2 June 2026

Our Ref: R/2025/15/C  
File No: 2026/242780  
Your Ref: SSD-93222706

**Advice on EIS – Waterloo Estate (South) Concept – SSD-93222706**

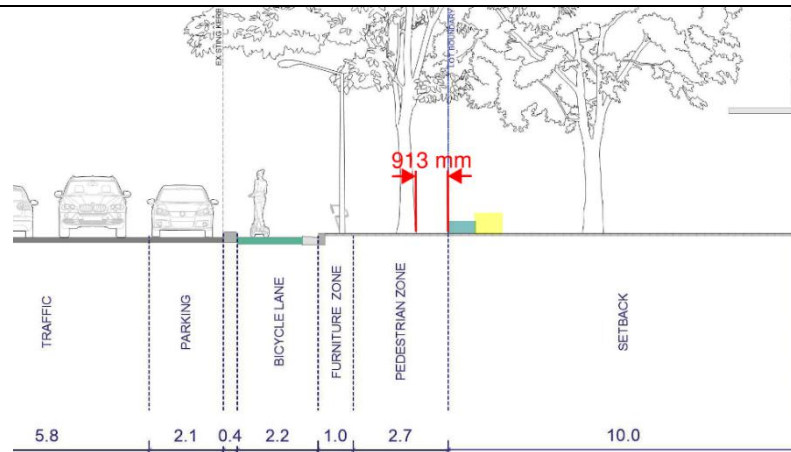
| Section              | Comment                                                                                                                                                                                                                                                                                                                                                                                                                                                                                                                                                                                                                                                                                                                                                                                                                                                                                                                                                                                                                                                                                                                                                                                                                                                                                                                                                                                                                                                                                                               |
|----------------------|-----------------------------------------------------------------------------------------------------------------------------------------------------------------------------------------------------------------------------------------------------------------------------------------------------------------------------------------------------------------------------------------------------------------------------------------------------------------------------------------------------------------------------------------------------------------------------------------------------------------------------------------------------------------------------------------------------------------------------------------------------------------------------------------------------------------------------------------------------------------------------------------------------------------------------------------------------------------------------------------------------------------------------------------------------------------------------------------------------------------------------------------------------------------------------------------------------------------------------------------------------------------------------------------------------------------------------------------------------------------------------------------------------------------------------------------------------------------------------------------------------------------------|
| Figure 20 (existing) | <p>Retain image and update to:</p> <ul style="list-style-type: none"> <li>• clearly define the boundary of each competitive design process site within each block</li> <li>• number each block to relate to the balance of the Design Guide</li> <li>• ensure the legend corresponds to the updated Figure noting that the lettered figure is not defined</li> <li>• be generally equivalent to the extent and number of sites as per Figure 20 of the Design Guide 2022</li> <li>• identify the sites dedicated to market, social and affordable housing.</li> </ul>                                                                                                                                                                                                                                                                                                                                                                                                                                                                                                                                                                                                                                                                                                                                                                                                                                                                                                                                                 |
